CITY OF BLOOMINGTON

**CITY OF BLOOMINGTON
PLAN COMMISSION AGENDA
July 7, 2014 @ 5:30 p.m.**

**BLOOMINGTON PLAN COMMISSION
STAFF REPORT
Location: 526 N. Morton Street**

**BLOOMINGTON PLAN COMMISSION
STAFF REPORT
Location: 700–730 N. Walnut Street**

Walnut Street Elevation

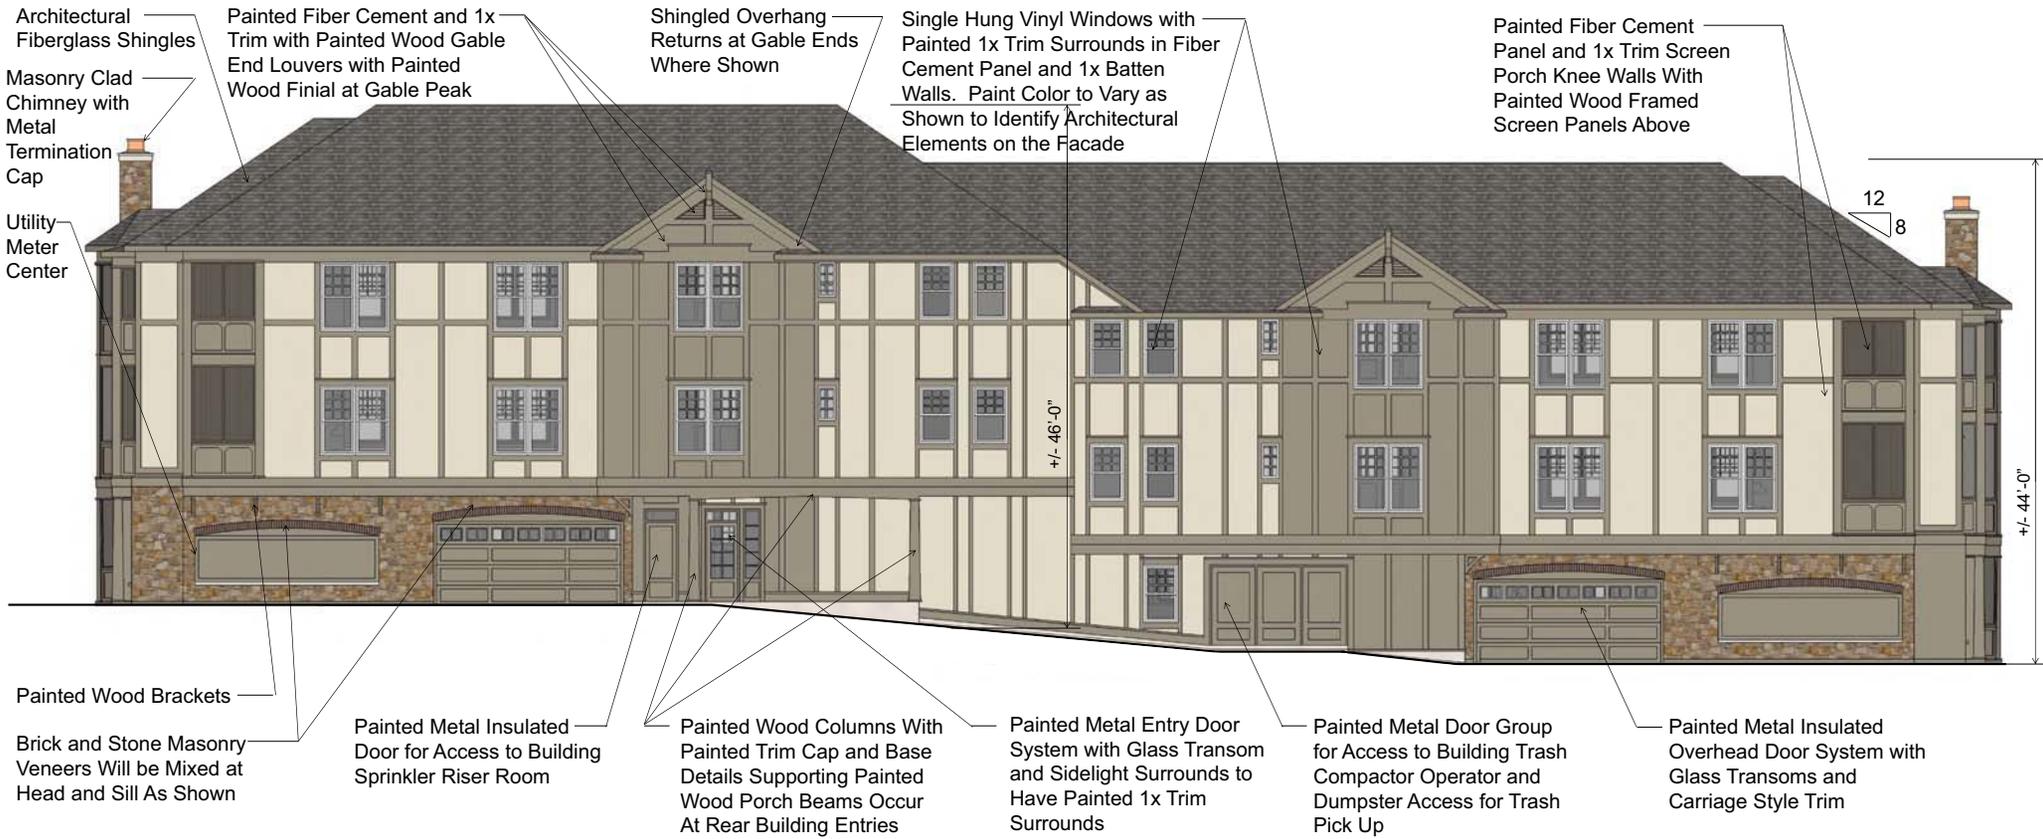
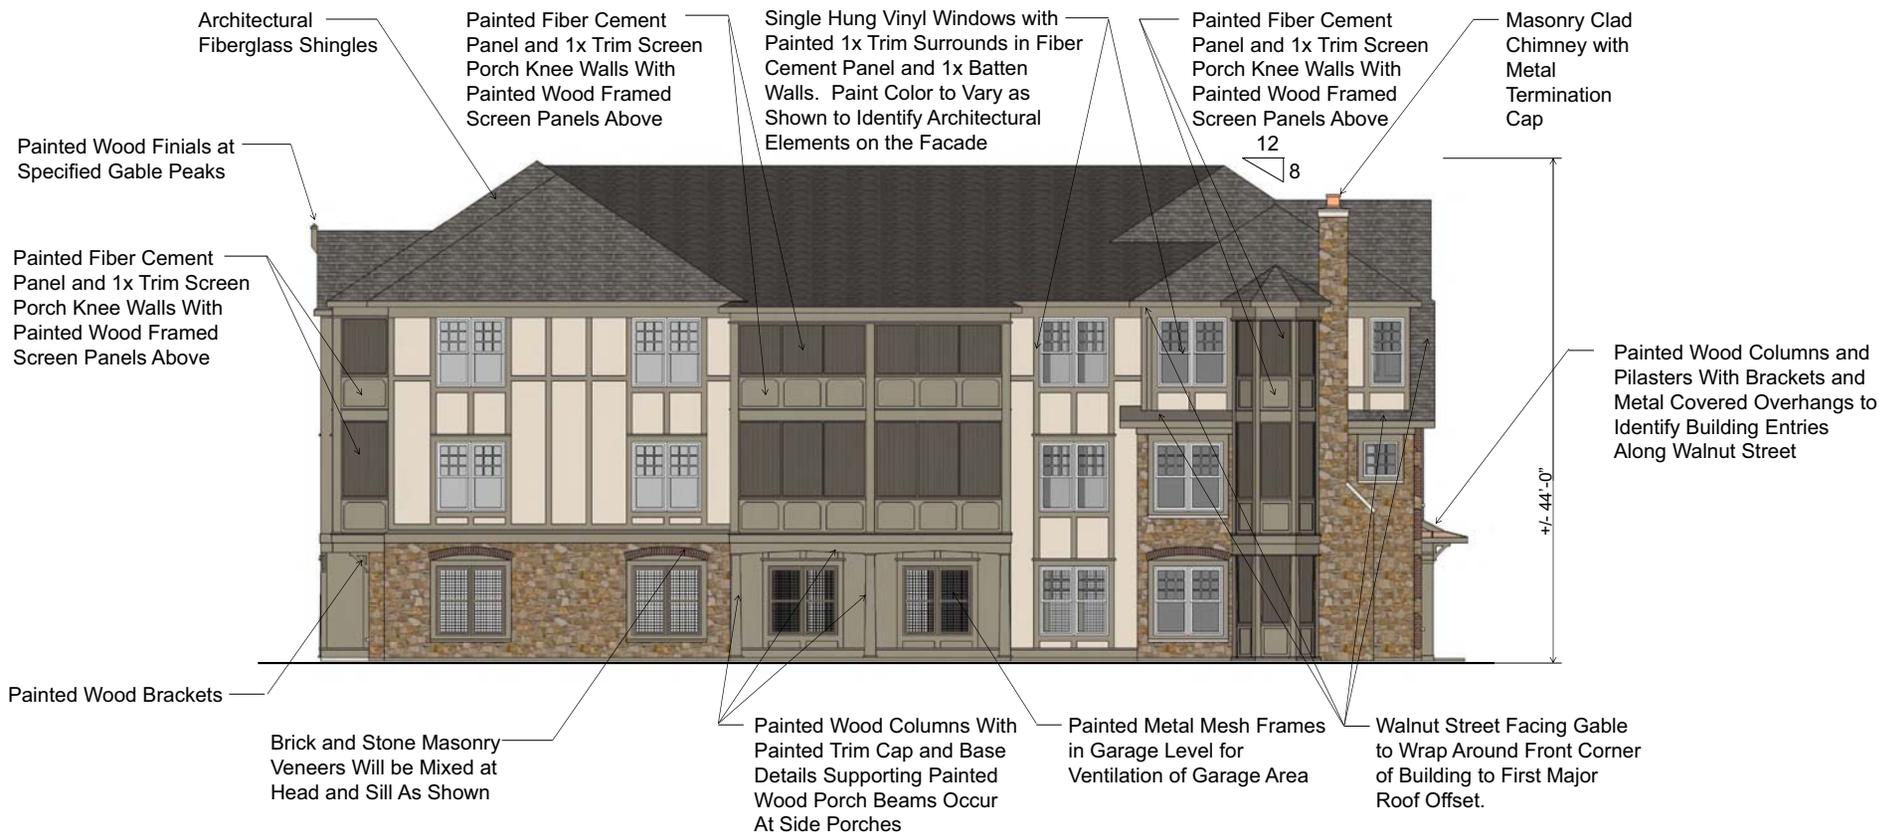
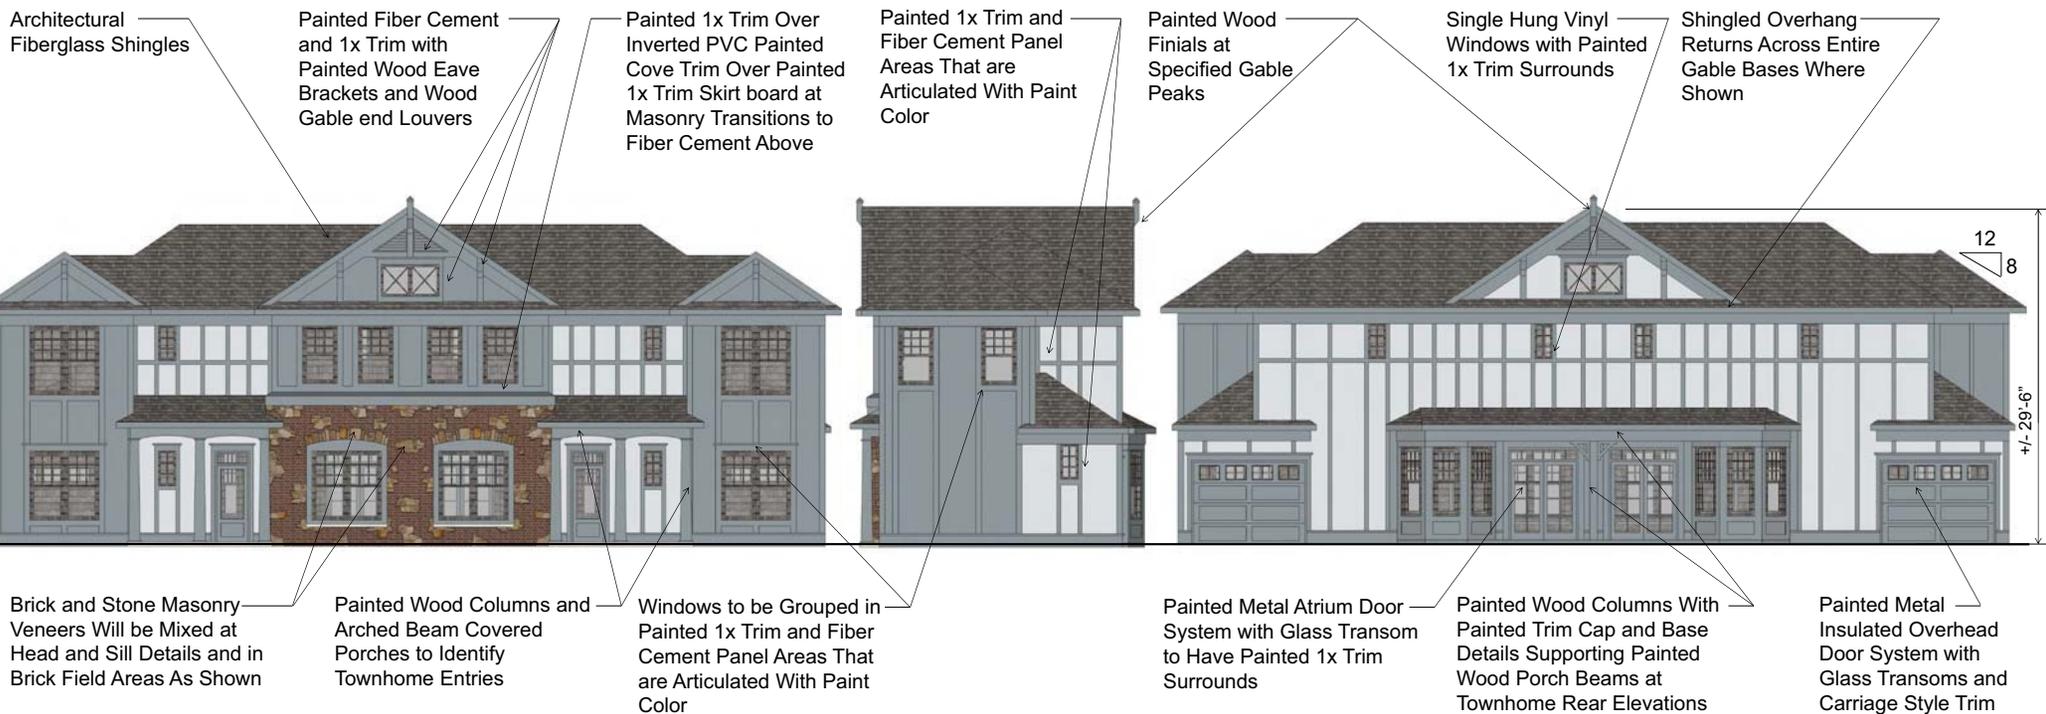
Height: The DEO district specifies a maximum structure height of 35 feet. The proposed 3-story structures range in height from 44-48.5 feet due to the grade change across the property. The townhouse structure is 29.5 feet in height and complies with this standard. ***The two larger structures would require a waiver of the DEO height standards.*** Although much of this overlay requires a pitched roof, this property lies along Walnut Street and permits either a flat or pitched roof. The petitioner has expressed that the intent of this waiver request is to allow a smaller building footprint that results in the proposed structures being located further to the west and a greater distance from the homes to the east. The proposed height is also a result of choosing a pitched roof. With the minimum pitch of 8:12, the structure is taller than a flat-roofed building. Both staff and the petitioner find a pitched roof to be more compatible and a better transition from the downtown structures to the west and the neighborhood to the east.

The Downtown Vision and Infill Strategy Plan (“Downtown Plan”) states that “*redevelopment in this character area should respond to the existing massing and scale of adjacent residential structures.*” Guideline 3.9 recommends that new buildings “maintain the perceived building scale of two to four stories in height.” It goes on to state that properties should “*develop a primary façade that is in scale and alignment with surrounding historic buildings.*” The petitioner has provided several exhibits and models that represent the visual impact of the proposed structures. In general, staff finds that 3-story, pitched-roof structures are located an adequate distance from the western property line and provide a desirable transition from larger flat-roofed, mixed-use structures on the west side of Walnut St. to the existing neighborhood to the east. However, staff would like to receive input from the Plan Commission as to the appropriateness of the proposed height. The alternative in this case is to require the petitioner to construct two-story structures with a pitched roof.

Façade Modulation: The DEO requires maximum module widths of 45 feet and offset facades. ***The petitioner is seeking a waiver from this standard.*** They have attempted to achieve the intent of this requirement through the inclusion of the courtyards. These provide much larger breaks in the façade than an offset of 3% of the building width. The requirement could be met by creating offsets of approximately 4.5 feet every 45 feet of each building. Staff finds the courtyards to be more effective in achieving articulation in the façade modules.
